DATE: February 1, 2023
TO: Potential Respondents
FROM: Elaine Robbins – Construction Contract Coordinator II
SUBJECT: Questions #1
RFCSP752-23-262094ER
UNT Music Practice Jazz Lab

UNT Jazz Practice Labs

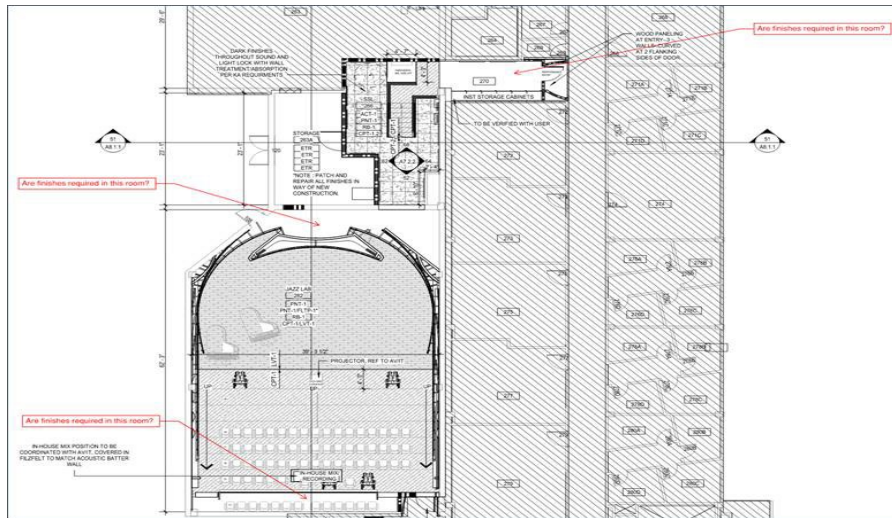
5. Room 270 also does not have materials listed, not sure if it's existing or not.

ANSWER: This room is a continuation of as part of room 266. Please use CPT-1 for this room on the floor; RB-1 for the base material; PNT-1 for the walls; ACT-1 for the ceiling.

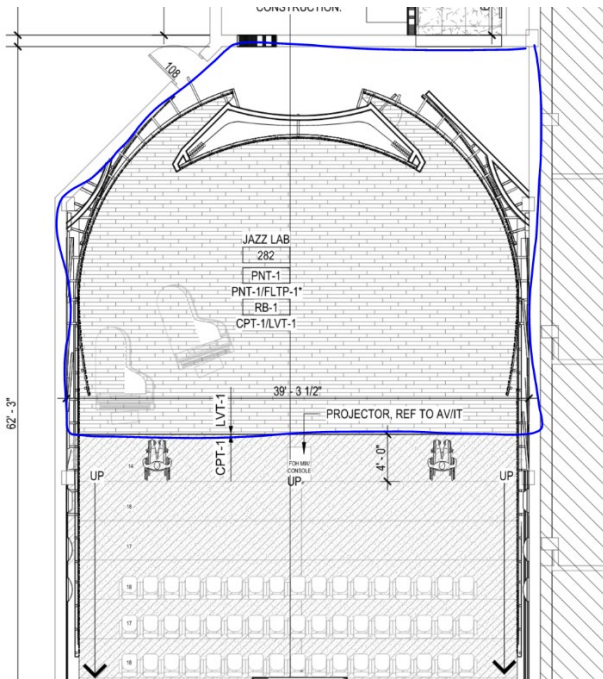
9. There are two areas on the finish plan that have no floor finish designation, they are the top row of the seating area behind the inhouse Mix/recording area in the lab Room 282 and the new ADA entry area corridor 270 where the instrument storage cabinets are. Do these two areas receive CPT-1 broadloom?

ANSWER: The space at the top of the audience zone shall receive CPT-1. The area denoted by the snip below, outlined in blue is all part of Room 282 and shall receive LVT-1. In conjunction with this all being the same room the walls received what the finish schedule calls out for this room.

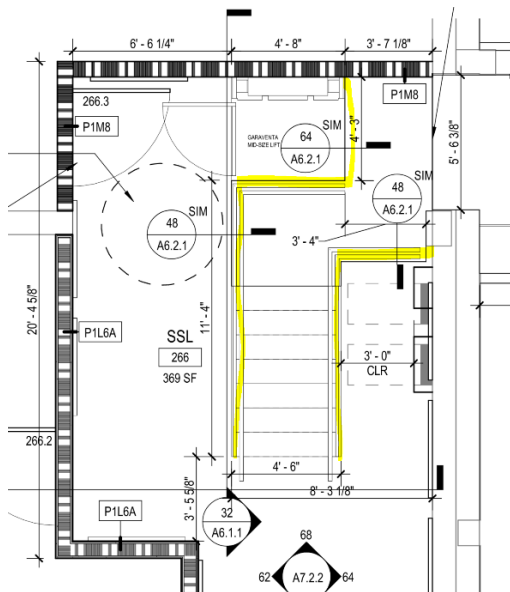
19. Details 1 & 2/S3.02 indicate new pavers at concrete pour back details, however, detail 68/A1.1.1 and Sheet S2/02 do not call out new pavers to be installed. Please provide specification section and material finish selections for new pavers scope. If pavers are not required, please specify desired concrete finish.

ANSWER: *New pavers to match existing.*

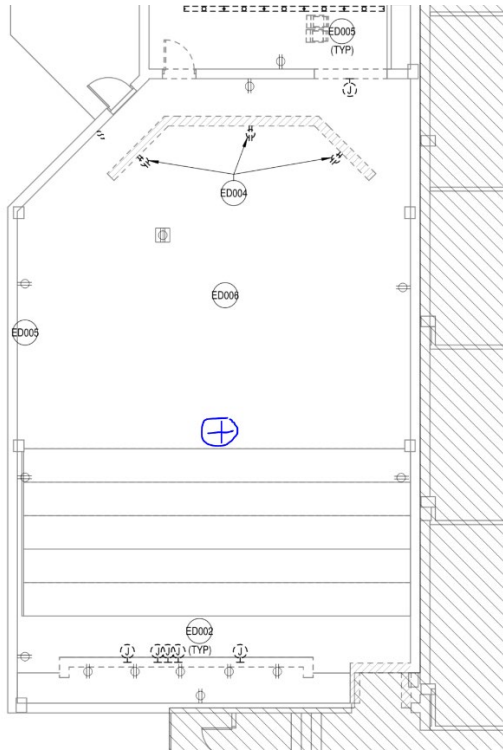
23. Sheet Keyed Note E208 indicates to utilize existing feed to equipment station for feed to new equipment rack, however, the existing feed is not shown on demolition plan ED2.1. Please clarify the power feed requirements for the new equipment rack. Also, please indicate number of pathways required and their termination point.

ANSWER: Existing location shown in snip below (next page). Contractor to reuse the pathway. Quantity of pull to be coordinated with AVIT documentation. Refer to Sheet T2.1.1 for additional information requested.
